CITY OF ALBUQUERQUE

Re: McDonalds - Gibson

5001 Gibson Blvd. SE Traffic Circulation Layout

Based upon the information provided in your submittal received 11-29-17, the above referenced plan cannot be approved for Building Permit until the following comments are addressed:

DATE BY NOV. 2017 HJM DESIGNED DRAWN NOV. 2017 HJM CHECKED 1/20/2017| DW AS-BUILT TRAFFIC CIRCULATION

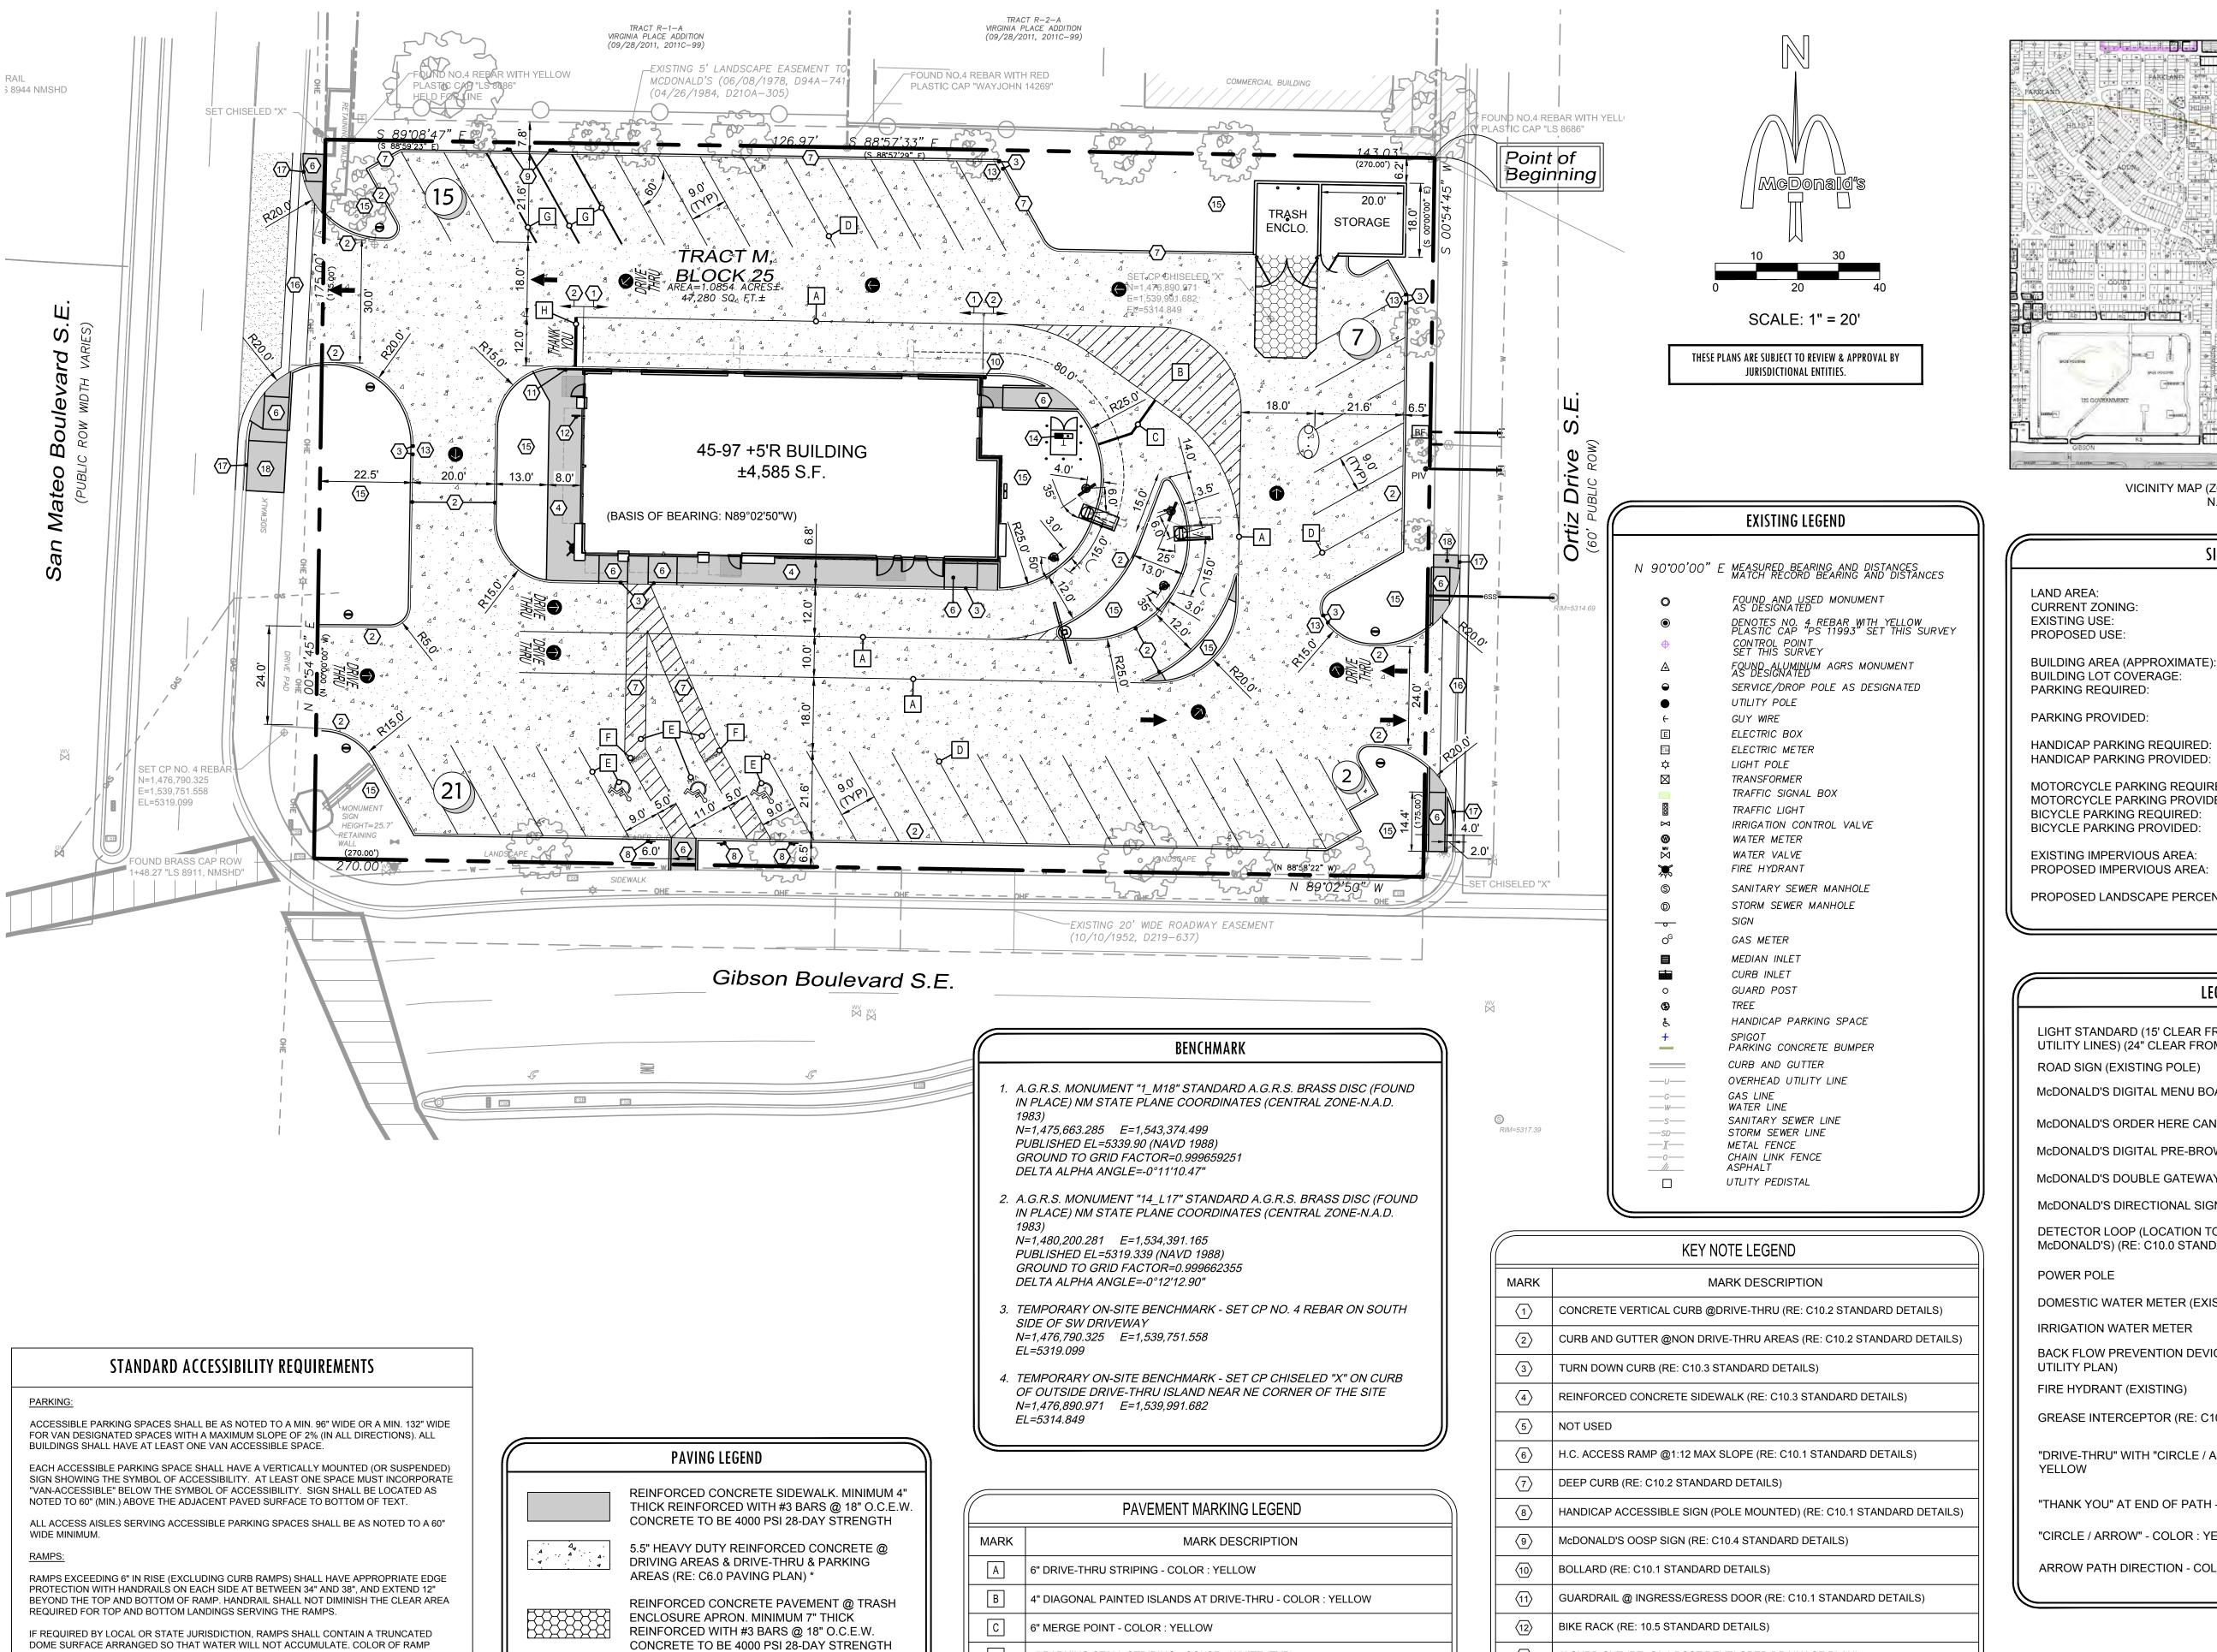
- 1. The traffic circulation layout must be stamped, signed, and dated by an engineer or architect licensed in the state of New Mexico.
- The ADA accessible parking sign must have the required language per 66-7-352.4C NMSA 1978 "Violators Are Subject to a Fine and/or Towing." Please call out detail and location of HC signs.

- ADA curb ramps in public right of way (ROW) must be updated to current standards and have truncated domes installed.
- 4. Motorcycle parking spaces shall be designated by its own conspicuously posted upright sign, either free-standing or wall mounted per the zoning code.

- 5. Per the zoning code, a 6 ft. wide ADA accessible pedestrian pathway is required from the public sidewalk to the building entrances. Please make the connection from the Public ROW to the building 6 feet.

- 6. You can eliminate the striping on the ADA path from the standard ADA parking spot to the building.
- One-way vehicular paths require pavement directional signage and a posted "Do Not Enter" sign at the point of egress. Please show detail and location of posted signs.

- 8. Unused curb cuts must be replaced with sidewalk and curb & gutter. A build note must be provided referring to the appropriate City Standard drawing.
